ADDENDUM NO. 03

Franklin Central High School Addition and Renovations Phase 3A.1
6215 S. Franklin Rd
Indianapolis, IN 46259

ADDENDUM NO. 3 (THREE)

DATE: April 4, 2025
PROJECT: Additions & Renovations to Franklin Central High School
Phase 3A.1
OWNER: Franklin Township Community School Corporation
PROJECT NO.: 2024040.00

- PIPE NORTH OF THIS VALVE IS CONSIDERED TEMPORARY CHILLER CONNECTION PIPING. PIPING TO BE REMOVED AFTER UNIT V IS CONSTRUCTED AND THE MAIN CHILLER CONNECTIONS ARE INSTALLED. SEE MD1H FOR FURTHER DETAILS.

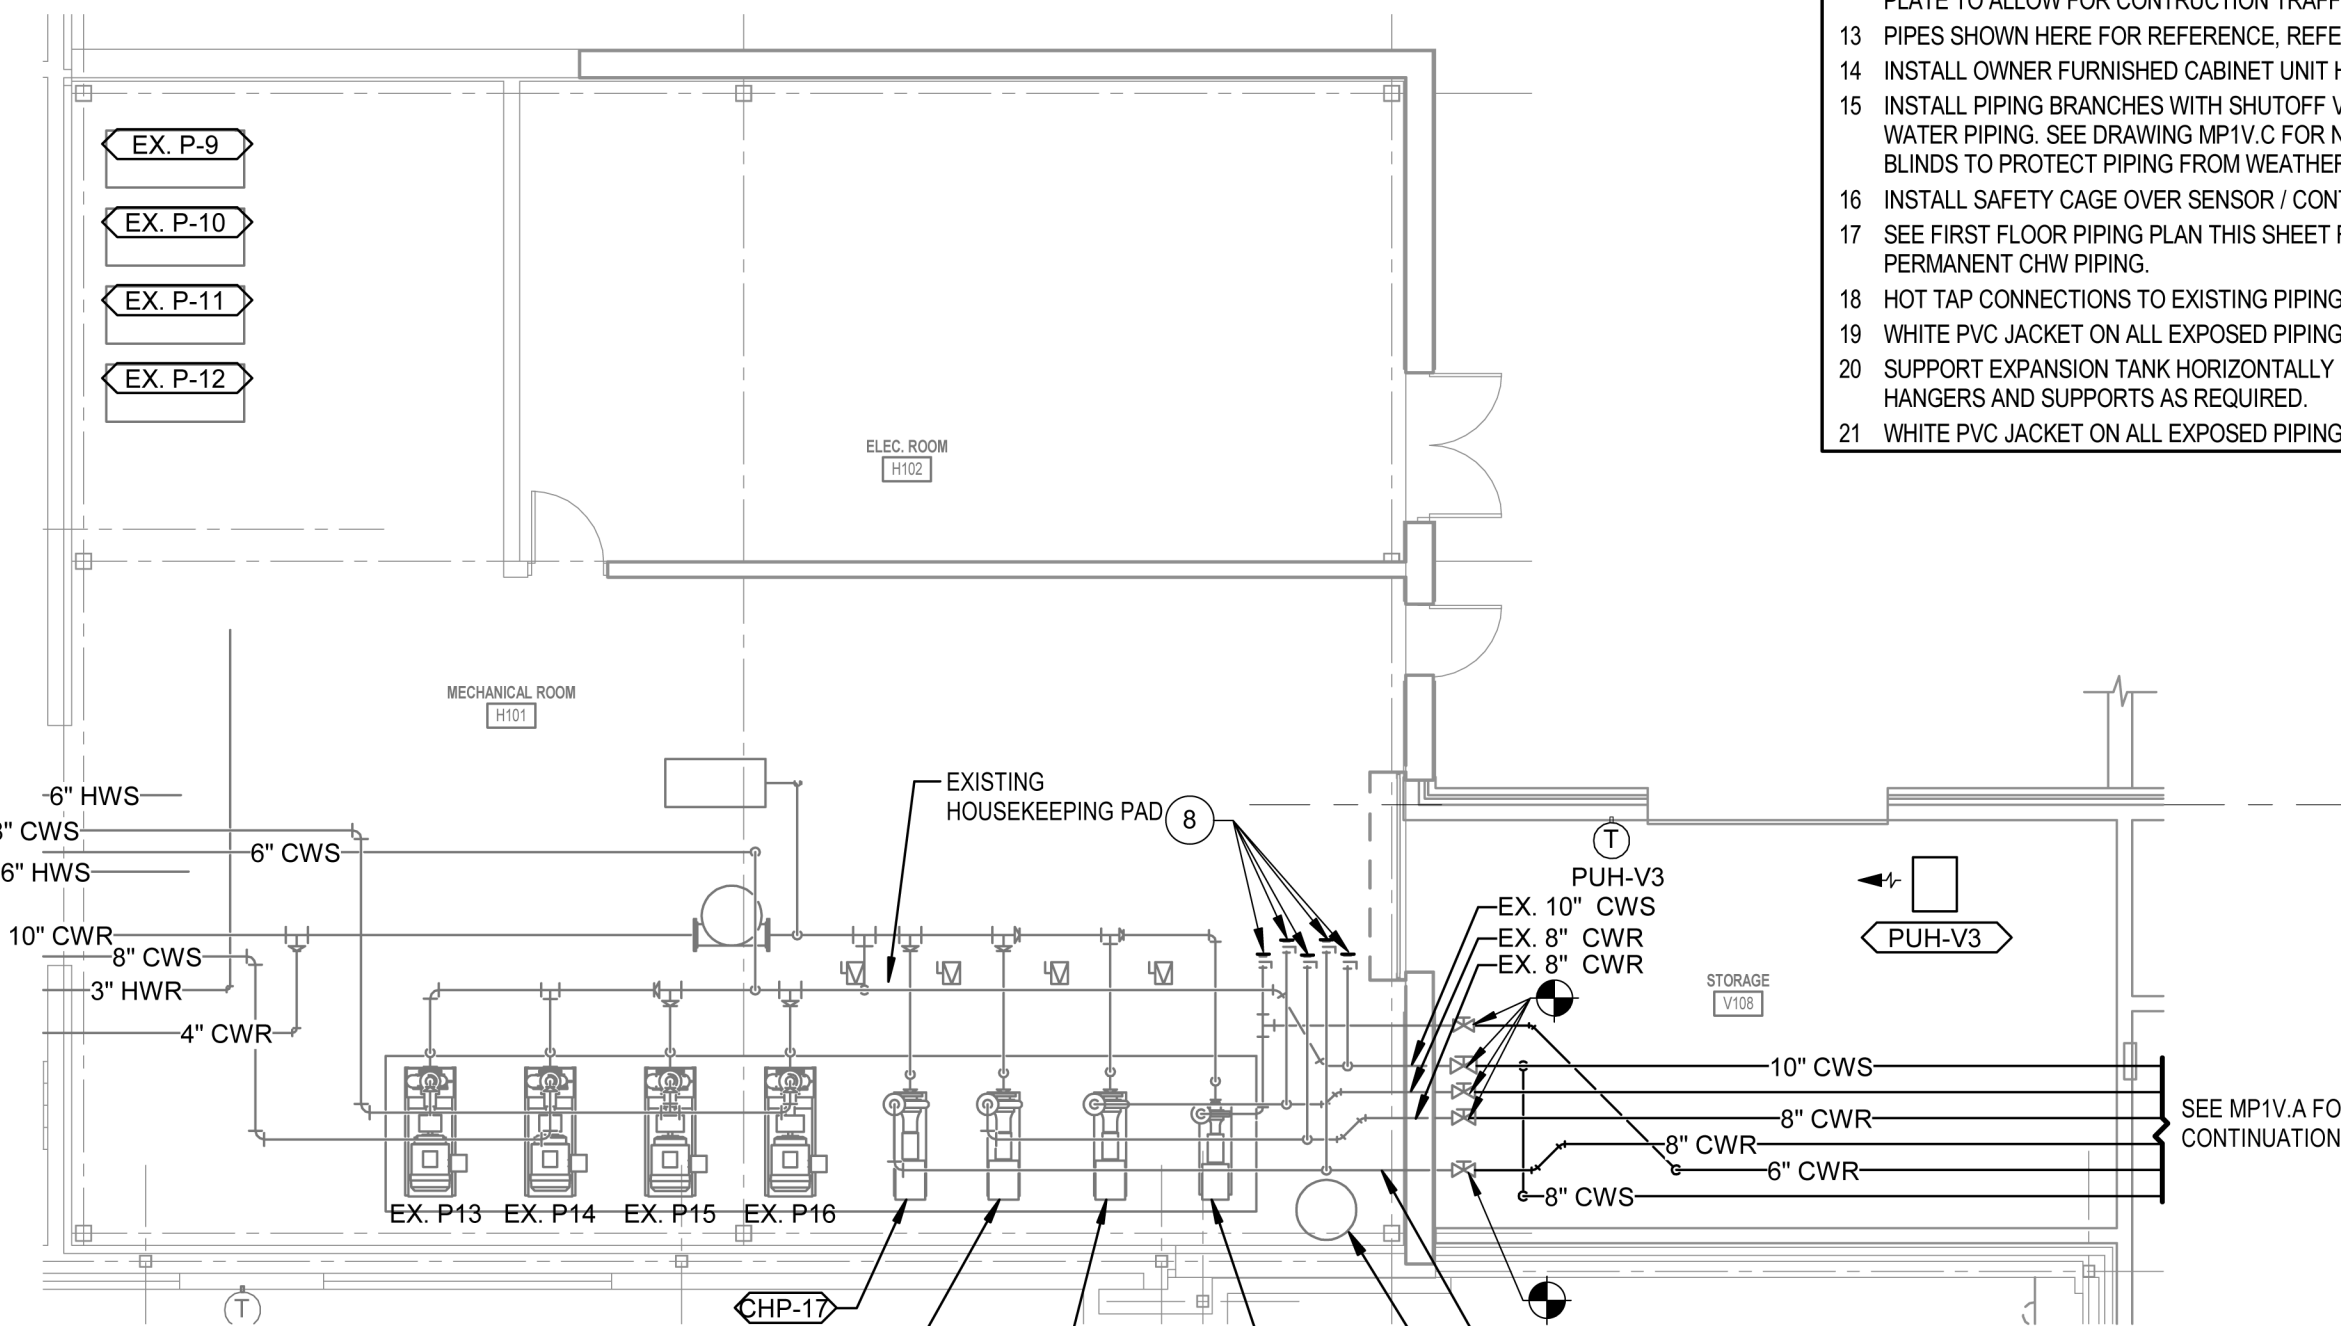
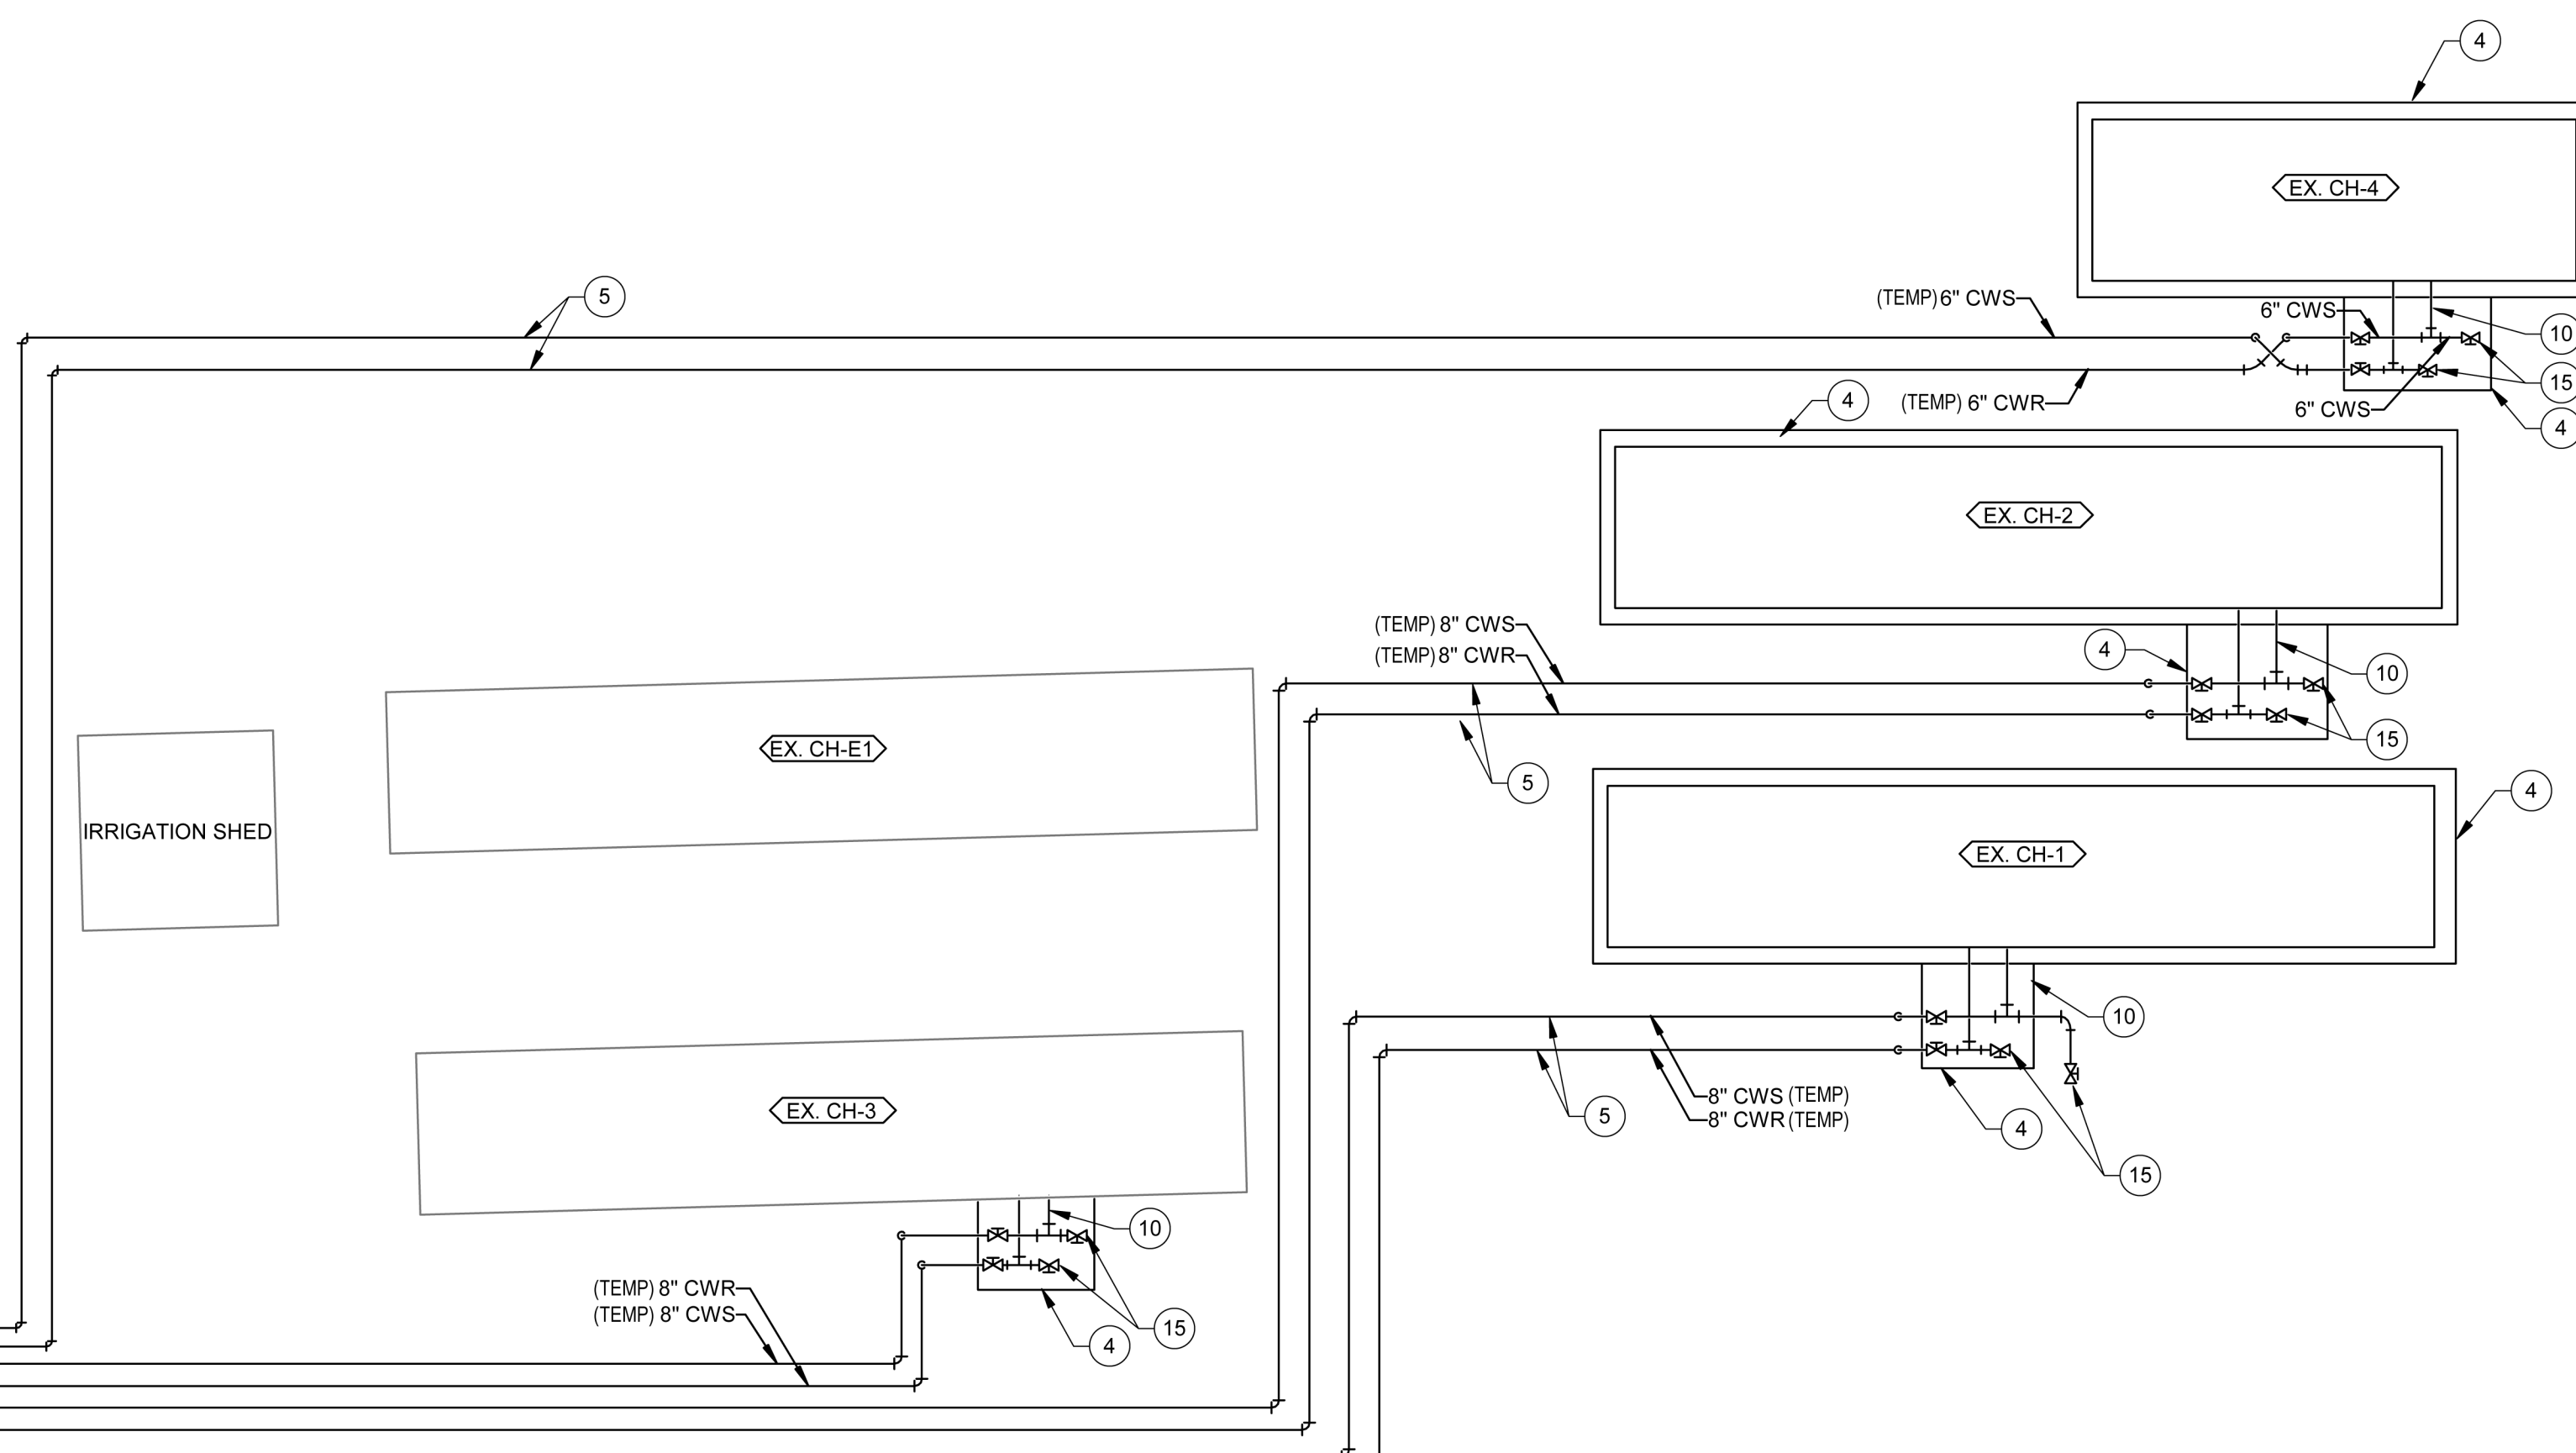
- 3-3 MP1H: Replace drawing in its entirety with attached revision indicating updated valves to gate and denoting locations of butterfly valves.
